**UNITED STATES OF AMERICA**  
**NUCLEAR REGULATORY COMMISSION**  
**BEFORE THE ATOMIC SAFETY AND LICENSING BOARD**

Pilgrim Nuclear Power Station

License Renewal Application

**Affidavit of Paul M. Blanch**

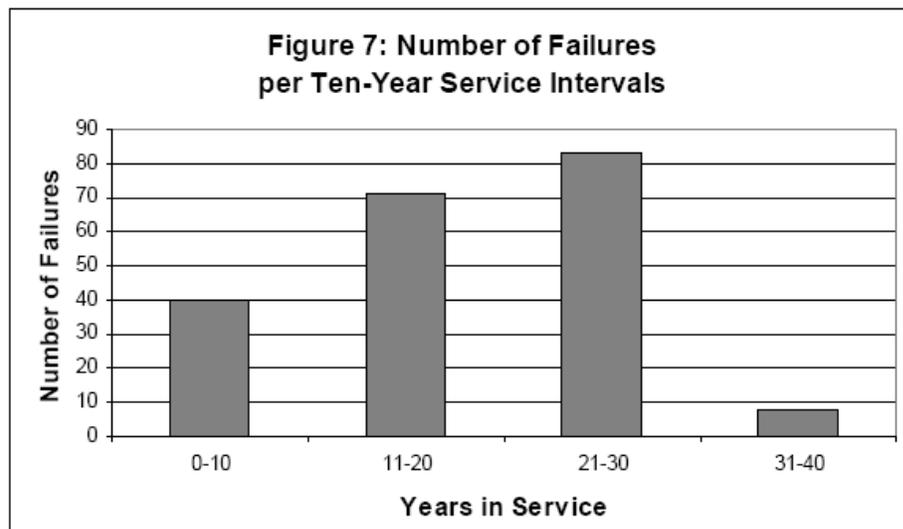
47. It is very clear that the number of cable failures is rapidly increasing with age as shown from the following graph copied from the NRC's own study titled "Inaccessible Or Underground Power Cable Failures That Disable Accident Mitigation Systems Or Cause Plant Transients"

48. It may appear that the number of failure decreases after 30 years however there were very few plants operating for more than 30 years. There is no reason to suspect that the number of failures will decrease unless the requirements of 10 CFR 50.49 are imposed by the NRC now that it is recognized many inaccessible cables are being subjected to design basis events that include conditions of normal operation defined by 10 CFR 50.49
